ADDENDUM 2

To: All Interested Proposers
From: Lucy Balderama, Inventory Bid Technician
Date: April 11, 2014
Subject: BID# 14-007, Construction of the Eastside Annex for the County of El Paso

**Eastside Annex 5'5" X
 9'0" Room 110 IDF.
 West Wall is 9'0" Long**

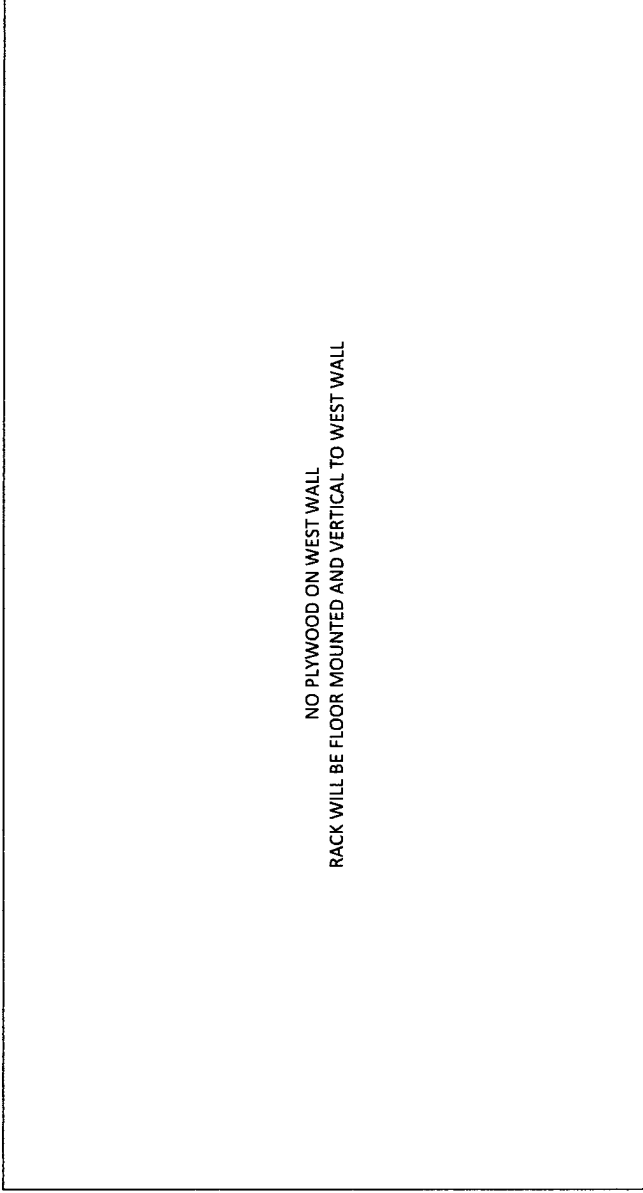
NO PLYWOOD ON WEST WALL
 RACK WILL BE FLOOR MOUNTED AND VERTICAL TO WEST WALL

**Eastside Annex MDF
Room 206 North Wall.**

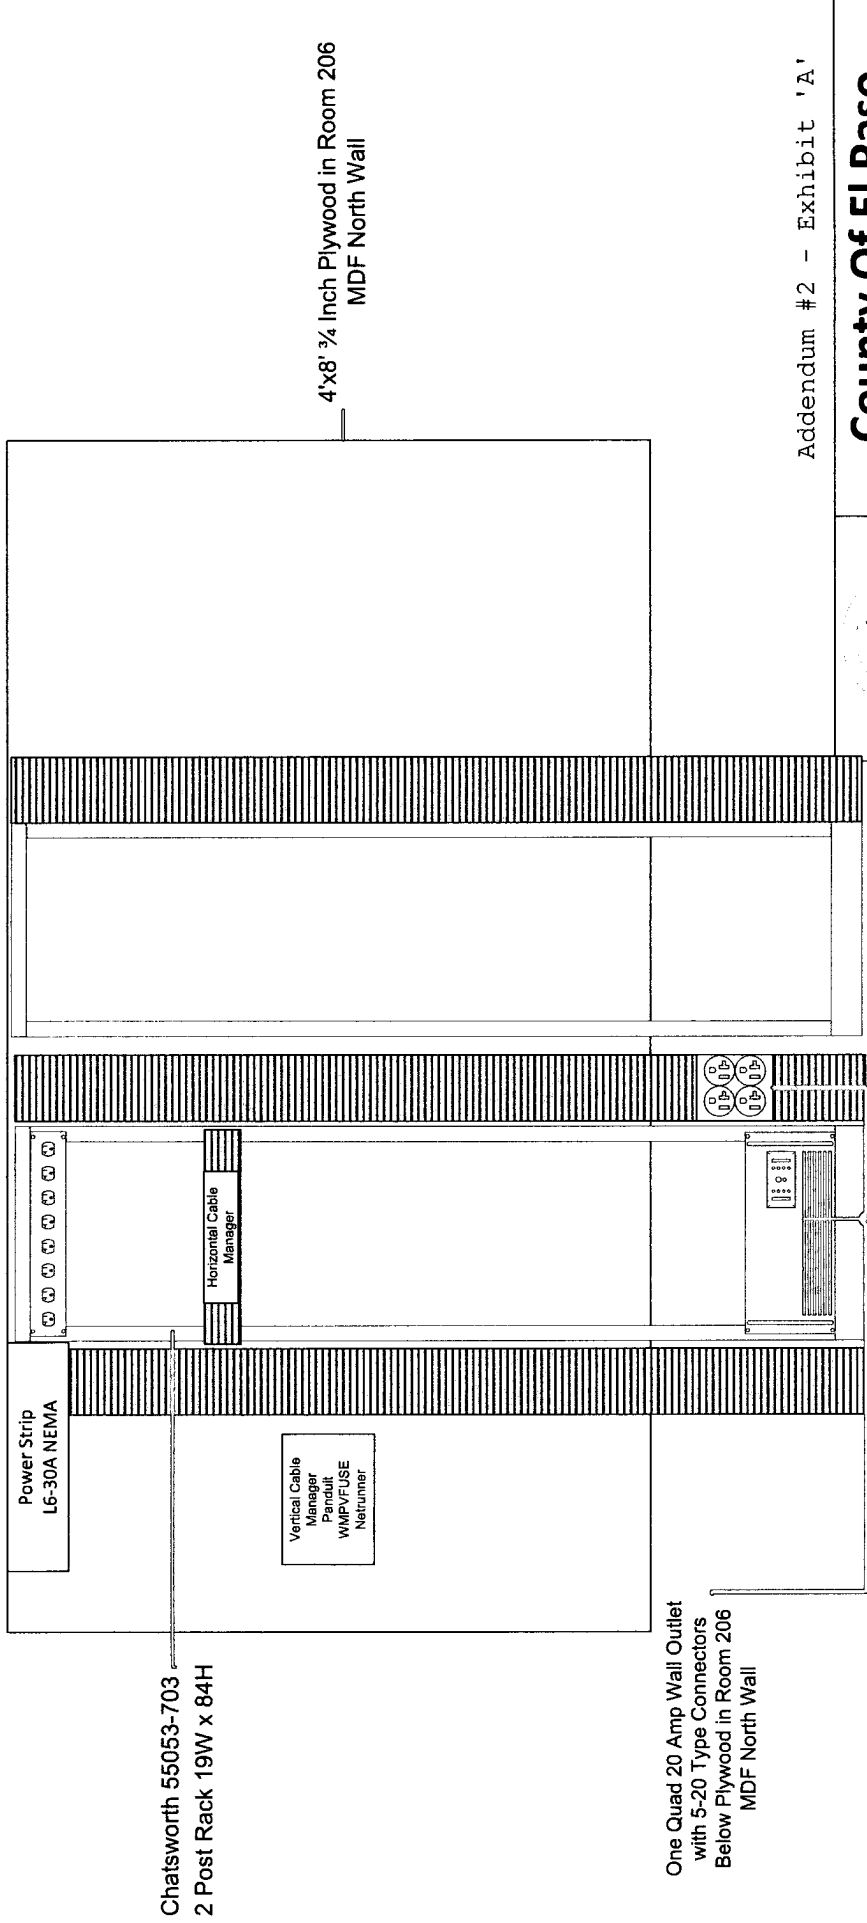
Two L6-30A NEMA and One Quad 20
Amp with 5-20 Connectors Above
Plywood and Rack in Room 206 MDF
North Wall

Chatsworth 55053-703
2 Post Rack 19W x 84H

One Quad 20 Amp Wall Outlet
with 5-20 Type Connectors
Below Plywood in Room 206
MDF North Wall
